## 15E ATWS Performance Evaluation

The information in this appendix of the reference ABWR DCD, including all subsections, tables, and figures, is incorporated by reference with the following departures.

Figure 15E-1a ATWS Mitigation Logic (ARI, FMCRD Run-In, RPT, Manual Initiation)

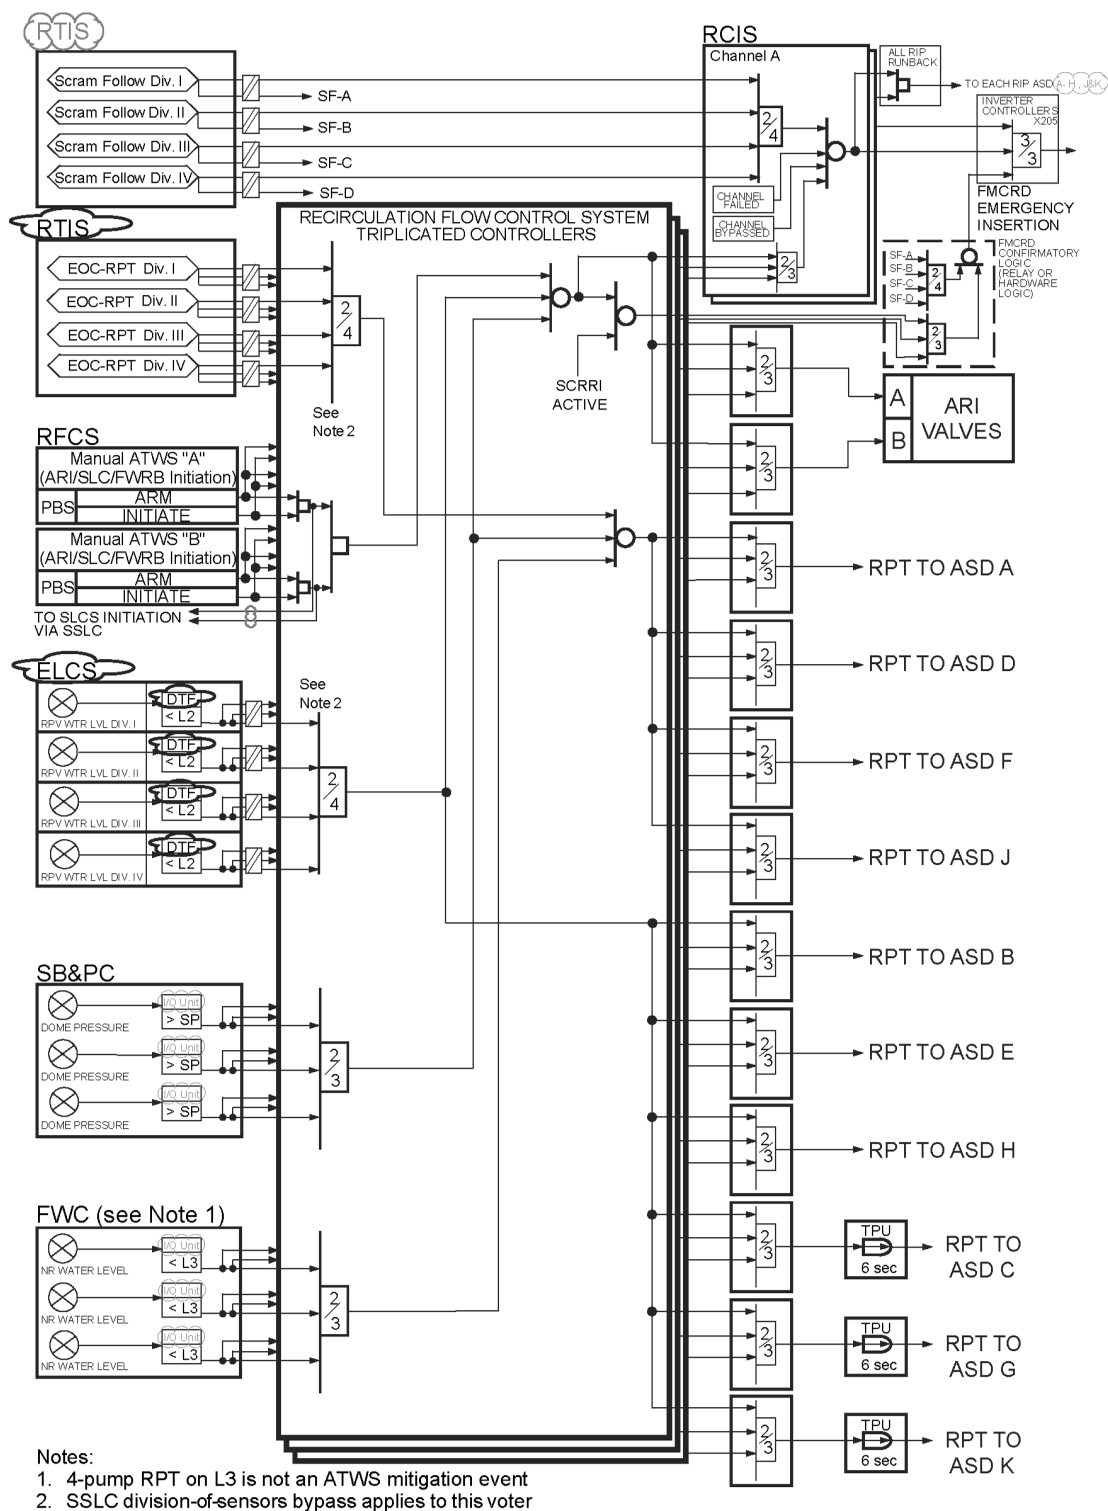
STD DEP T1 3.4-1 (Figures 15E-1a, 15E-1b, 15E-1c)

STD DEP Admin ( Figure 15E-1a, Figure 15E-1b)

Figure 15E-1b ATWS Mitigation Logic (SLCS Initiation, Feedwater Runback)

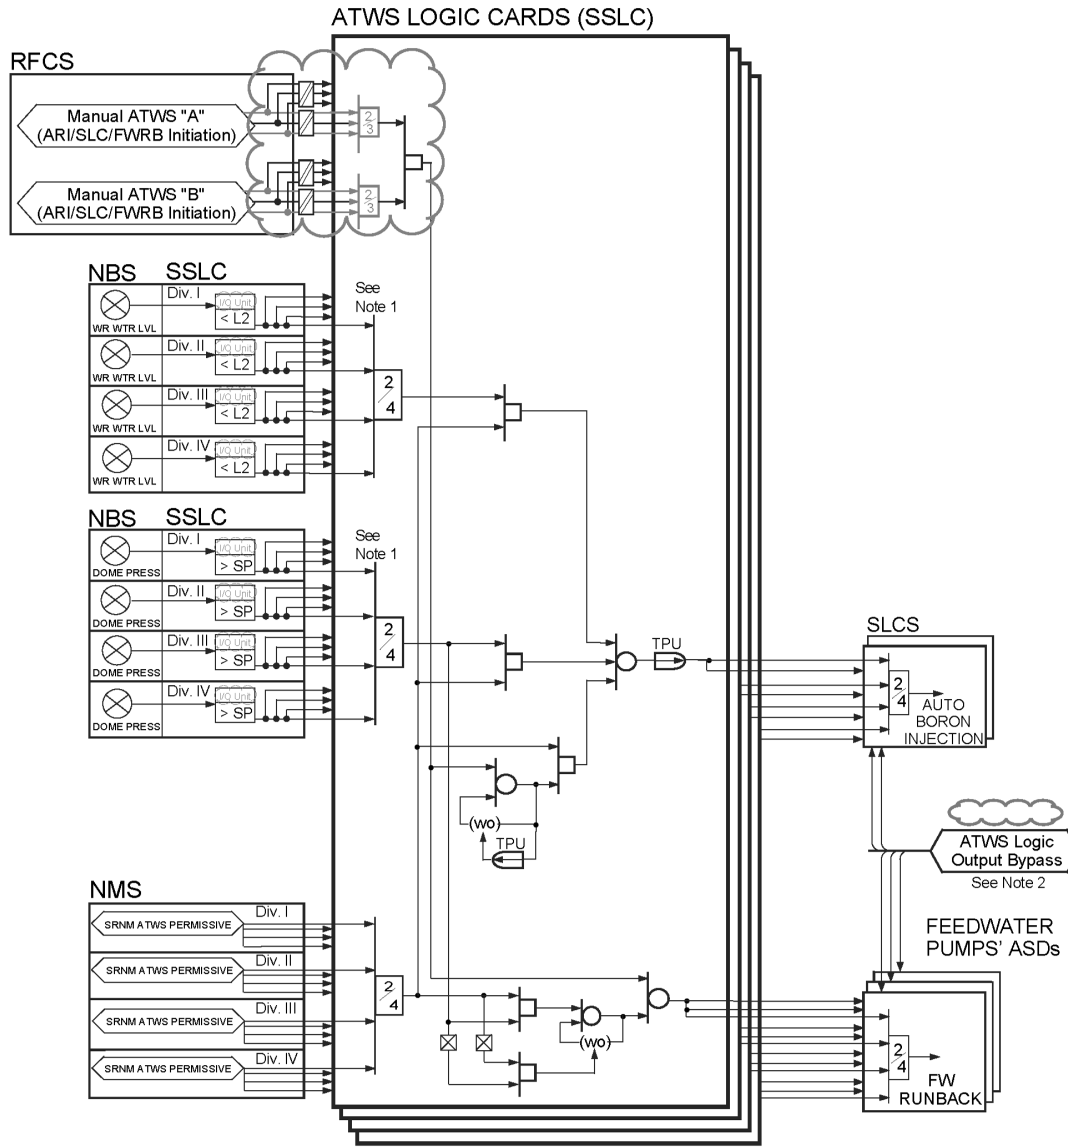
STD DEP 16.3-83 (Figure 15E-1b)
